ADDENDUM NO. 2

Date: October 13, 2017
To: All Bidders
From: Boyce H. Evans, Purchasing Agent, City of Knoxville
Subject: Addendum No. 2 – 2018 Sidewalk Replacement Project

2018 Sidewalk Replacement Project

CONCRETE SIDEWALK WITH COMBINED CURB AND GUTTER

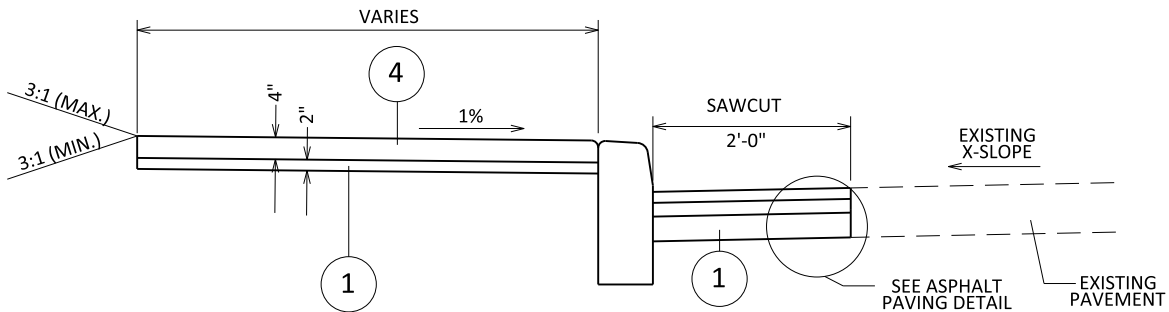
5. Q: Please revise the drawings to include a Detail like the one referenced per Item 4 above to show:

- Item 12.62 Combined Curb & Gutter and
- Item 12.65 Concrete Curb Type A.

Please address saw cutting and asphalt paving as in item 4 above

A: See attached details with this addendum.

SIDEWALK GUTTER DRAIN, 3" PVC PIPE DETAIL

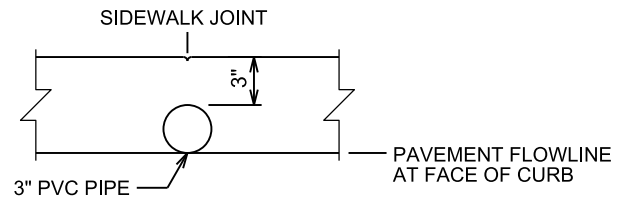
6. Q: Please revise the drawings to include a Detail for Item 20.10 Gutter Drain.

A: See attached detail with this addendum. This pay item will only be used to replace gutter drains that are damaged prior to removal of existing sidewalk.

THIS DETAIL IS TO PRESENT THE TYPE OF MATERIAL AND LAYOUT OF THE 3" PVC PIPE THROUGH THE SIDEWALK

IN SOME CASES THE CONTRACTOR SHALL GO THROUGH EXISTING CURB OR PROPOSED CURB WITH GUTTER DRAIN PIPE.
